Guangzhou Juan Intelligent Tech Joint Stock Co.,Ltd

Class II Permissive Change Letter

FCC ID: 2APRB-WNIP-2L-BU

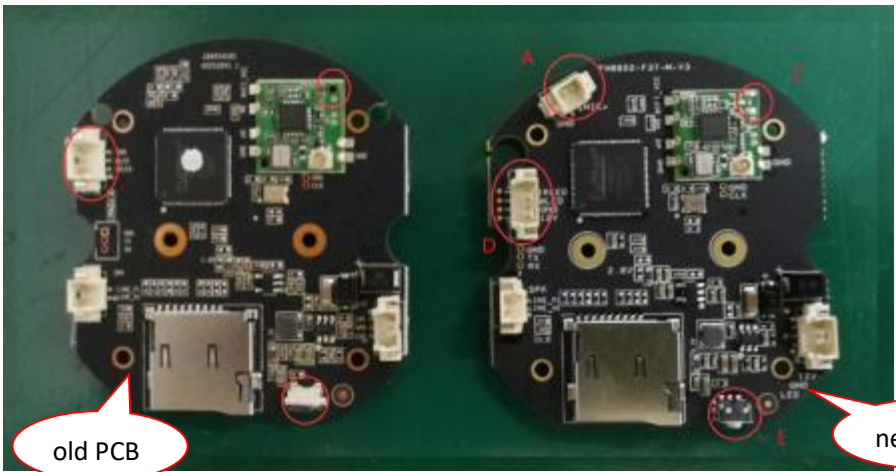
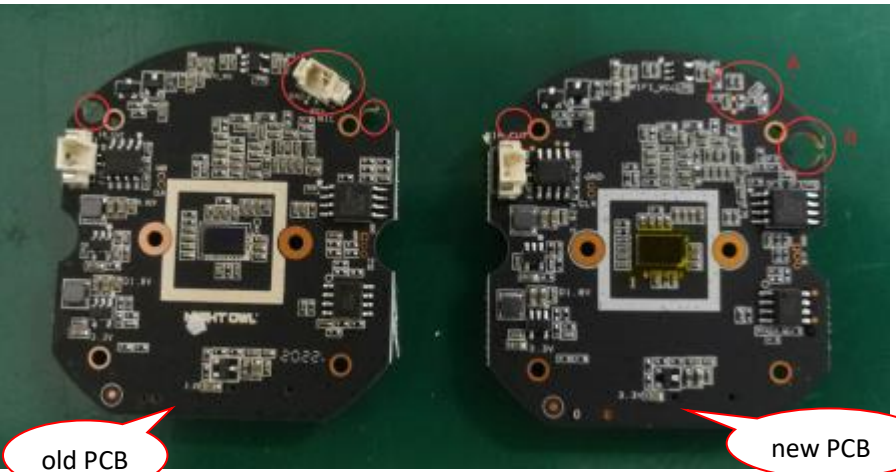
Delete the Magnet charger port, loudspeaker and change the camera LED panel there is only

Change to:	 <p>old PCB</p> <p>new PCB</p>
Change to:	 <p>old PCB</p> <p>new PCB</p>

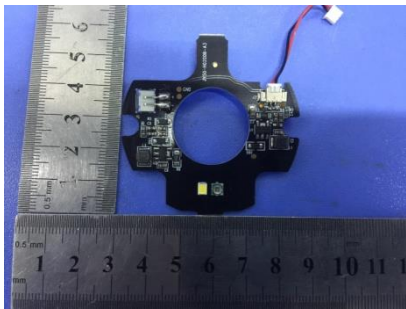
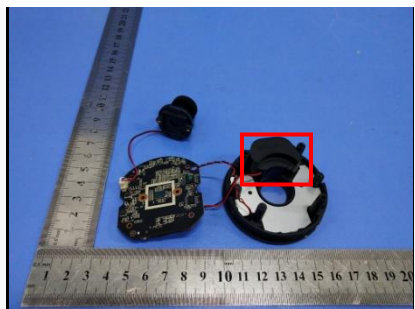
Change to:		
	Old Camera LED panel	New Camera LED panel
Change to:		
	Old loudspeake	New loudspeake
